RSB 575
March 25, 2022

NHTSA #22V 043
TC #2022-035

RECALL SERVICE BULLETIN

2020 – 2022 :: Super Star, Supreme Aire

Valve Stem Extension and Stabilizer Work Instructions

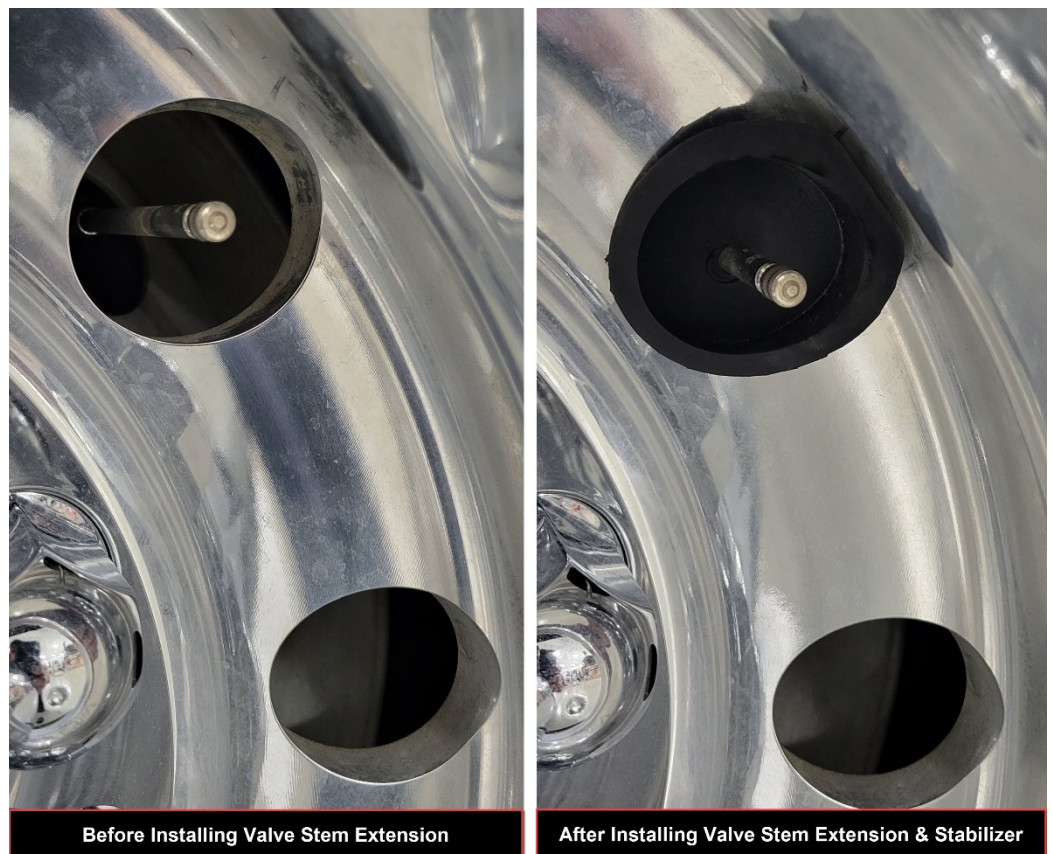
On certain motorhomes, the tire valve stem extension for the inner wheel may contact the outer wheel rim opening. This may potentially damage the valve stem extension and result in loss of air pressure in the inner tire. This could increase the risk of a crash.

If no leaks are detected, install the rubber stabilizer by putting the valve stem extension through the center hole. Then push the stabilizer into the rim with the flat side toward the dish of the rim and away from the lug nuts.

Take pictures of the original valve stem extension installed, then remove the valve stem extension. Be sure to note any damage to the valve stem or valve stem extension (with picture). Install the new valve stem extension.

Check for leaks. Shine a light and use a mirror, if needed, to make sure no leak developed during the installation of the stabilizer.
